Arun District Council

Our Ref: HA/4274/001

I am writing to provide you with additional information regarding the proposed drainage strategy for the proposed development at The Old Butcher's Flat, Climping Street, Climping. Within this document are enclosed site infiltration testing results and a CCTV survey of the existing site drainage.

DWG TITLE: INDICATIVE SURFACE WATER DRAINAGE LAYOUT

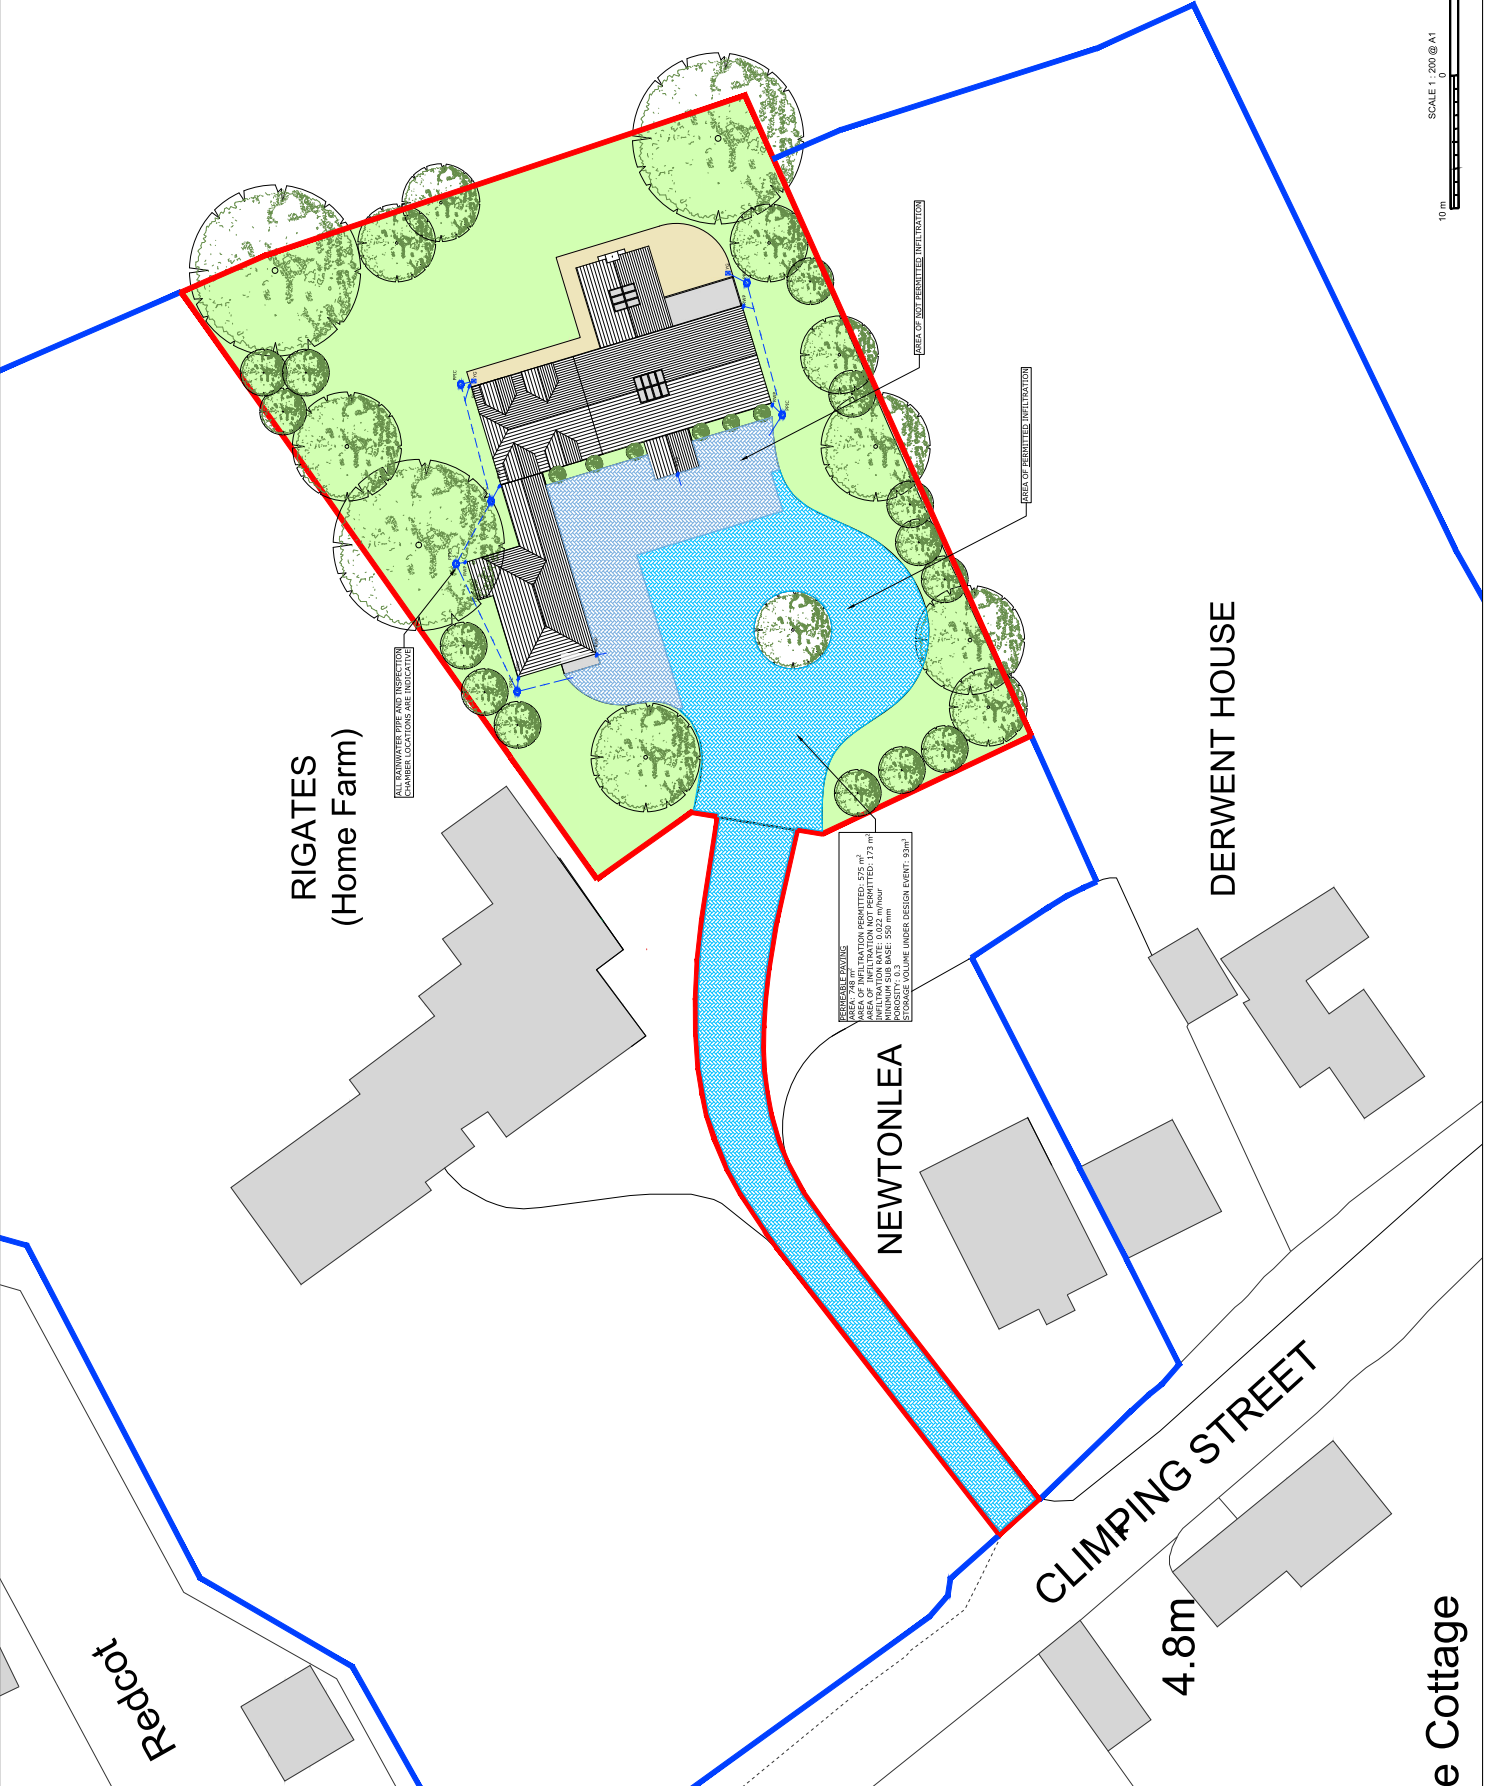
The proposed permeable surfacing, from which infiltration has been allowed via the subbase, is designed at a depth of 0.55m. The depth of proposed subbase is similar to the depth of the second trial pit, therefore the infiltration rate of 0.022m/hour has been utilised from the permeable surfacing. An updated set of calculations and surface water drainage drawing has been included within the enclosed documents to reflect the results from the testing on site.
